ES_LPC3240

Errata sheet LPC3240

Rev. 9 — 1 June 2011

Fig 2. Scope shot 2 - actual read timing

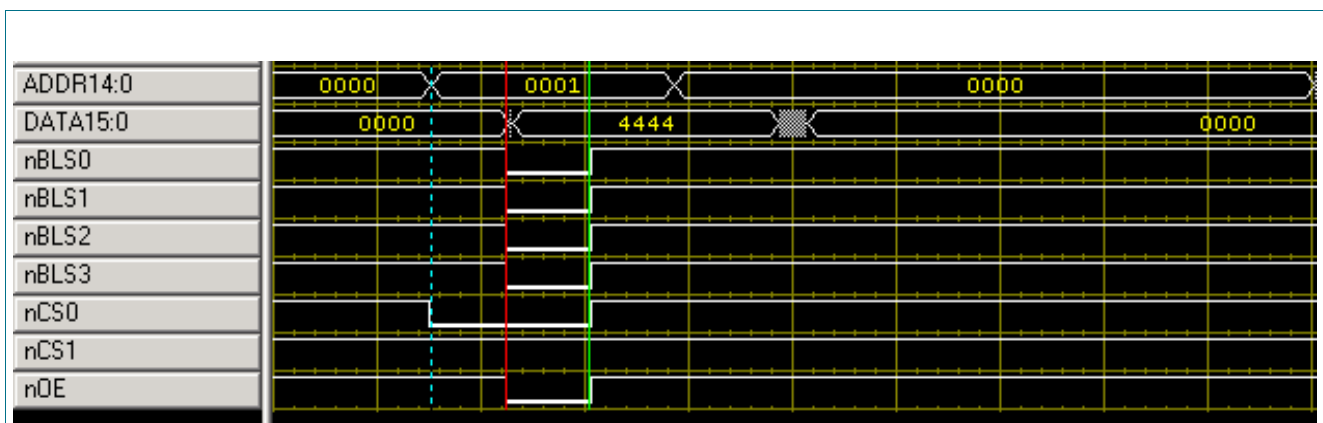
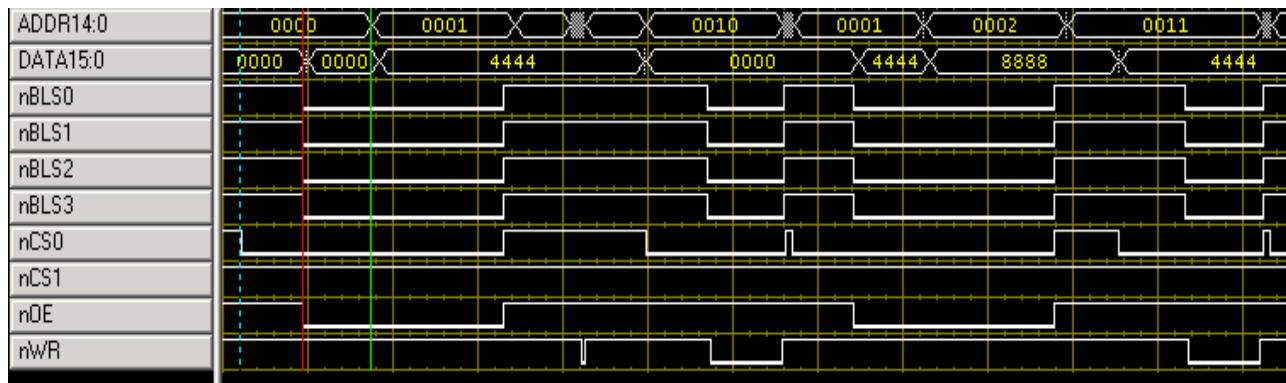
When using memory-to-memory DMA with the EMC static chip select (EMC_CS[x]_N) as the DMA source and the DMA channel source burst size is set for a single transfer (DMACCxControl:SBSIZE = 0), each DMA source read should be a single bus-wide access. The access should be similar to reading the EMC_CS[x]_N static memory with an ARM LDR instruction, as shown in [Figure 1](#). Note the EMC signal timing for the read is controlled by the EMCSTATICx registers. In all example scope shots the EMCSTATICWAITx registers are set to the maximum value.

However, the actual EMC timing for the source DMA read is a double wide chip select with a burst of two reads (notice how the address increments near the halfway point of nCS0 active), see [Figure 2](#). The second data read during the burst is discarded, as the DMA destination write (also to nCS0 in [Figure 2](#)) following each read, always writes the first value read during the read burst. When the DMA source address is set to auto-increment, the last DMA read transfer will address the last address of the source buffer and the last source buffer address +1. This behavior only happens during the read part of the DMA transfer. Memory-to-memory DMA destination writes to the EMC static chip select work as expected.

1. Avoid using DMA to transfer read blocks of data from the external device. Instead use a software loop with LDR instruction to read blocks of data from the external device.
2. If DMA can't be avoided, ensure there is at least one unused address between the highest address used for the external device DMA data buffer and any status or control register in the device that will initiate any unwanted action just by reading from the register (i.e. clear an interrupt or status).

Fig 3. 128 MB DDR SDRAM example

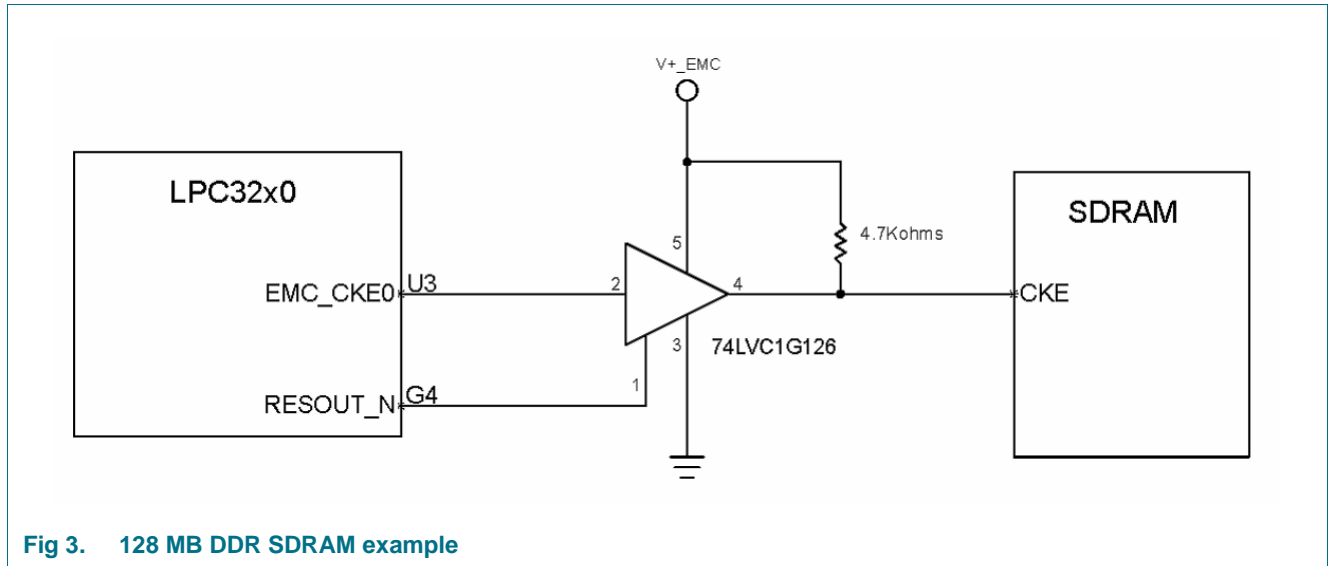
If the LPC3240 is reset during an SDRAM access, the SDRAM clock and clock enable will be immediately de-asserted. If the de-assertion occurs during the period of time the SDRAM is driving the data bus, the SDRAM will hold that state until the next clock occurs at the SDRAM clock input when the clock enable is active. However, the LPC3240 won't deliver the clock and clock enables until software actually sets up the EMC state to do this, so the SDRAM will remain in the data assertion state on the data bus while the LPC3240 tries to boot.

When the chip attempts to load boot code from NOR FLASH after reset, the correct signals are asserted to the NOR FLASH device and the NOR FLASH device places its data on the data bus. But if the SDRAM is still driving the bus, the NOR FLASH device and SDRAM device are in contention and the data will not be read correctly into the LPC3240. In this situation, the LPC3240 will fail to boot.

If booting from NOR FLASH is a requirement, the simple circuit shown in [Figure 3](#) can be used to clear the SDRAM state at system reset. This will not change the normal functioning of the LPC3240 EMC or SDRAM operations. If SDRAM devices are also present on the 2nd SDRAM chip select, a similar circuit will be needed for those devices using EMC_CKE1.

Fig 4. Basic DDR write timing

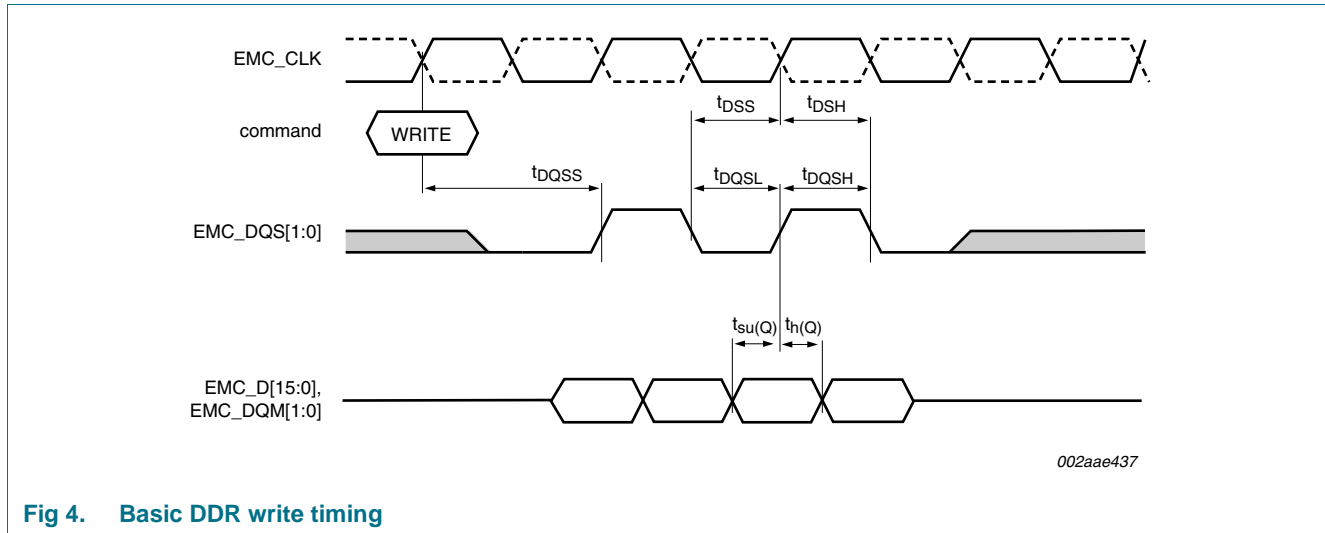
For DDR writes the LPC3240 drives the EMC_DQS[1:0] earlier in the data valid window than center aligned. With the EMC_CLK at 133 MHz this produces a minimum set-up time between the EMC_D[15:0] and EMC_DQS[1:0] of 600 ps across silicon process, voltage and temperature. Test conditions are with the EMC buffers set to fast slew rate driving 2 inches of 50 Ω transmission line and 10 pF load capacitance. DDR memories specify EMC_D[15:0] to EMC_DQS[1:0] set-up time minimum as 400 ps. This leaves 200 ps set-up time margin due to customer specific load and PCB layout implementation. See the LPC3220_30_40_50 data sheet for the complete range of DDR data output set-up time, $t_{su(Q)}$, and data output hold time $t_{h(Q)}$ times.

1. The DDR initialization software should set the SDRAMCLK_CTRL register (0x4000 4068) SDRAM_PIN_SPEED[3:1] bits = 0 (fast slew rate). This is for both 1.8 V mobile and 2.5 V DDR memories.

Fig 5. 128 MB DDR SDRAM example

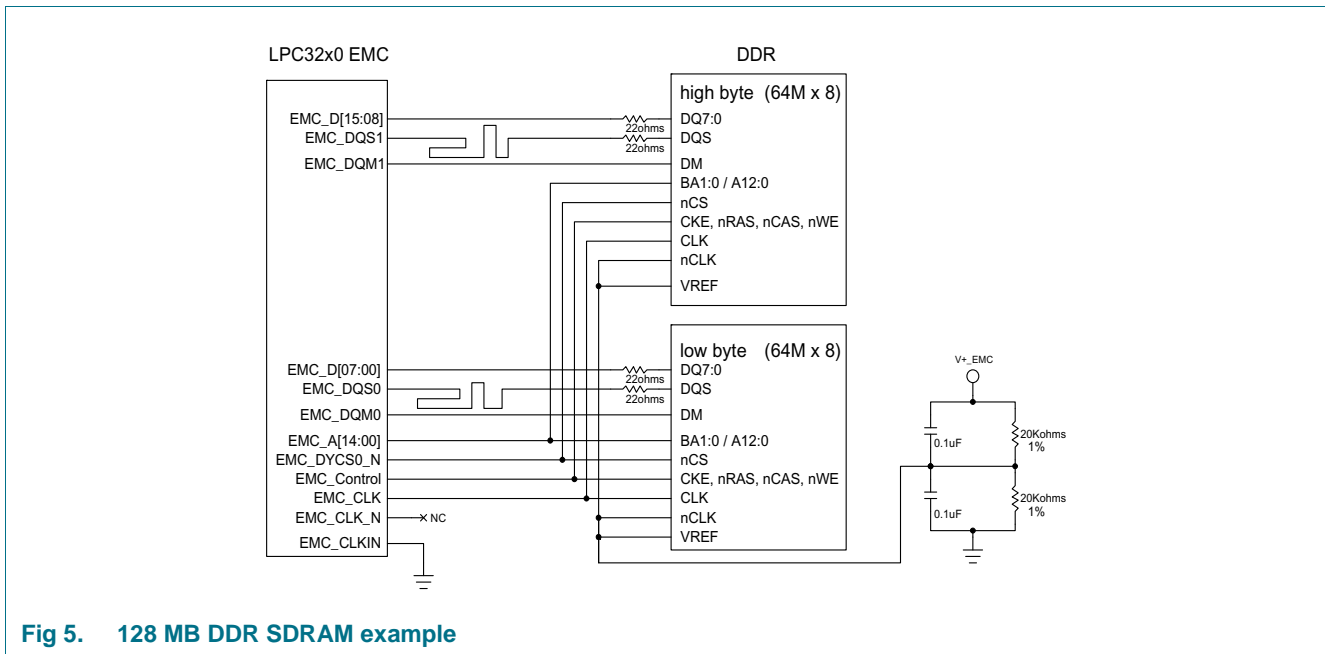
2. Systems requiring 128 MB or less of DDR should be implemented using a single EMC_DYCSx_N for DDR. The single chip select system may be constructed with a single 16-bit wide DDR or two 8-bit wide DDR SDRAMs using up to the maximum supported 512 Mbit DDR density. Using two 8-bit wide DDRs will have less capacitive loading and facilitate simple point-to-point routing of EMC_D[15:0] and EMC_DQS[1:0] signals over using two 16-bit DDRs and two EMC_DYCSx banks.

Example 128 MB system DDR SDRAM using a single EMC_DYCSx_N:
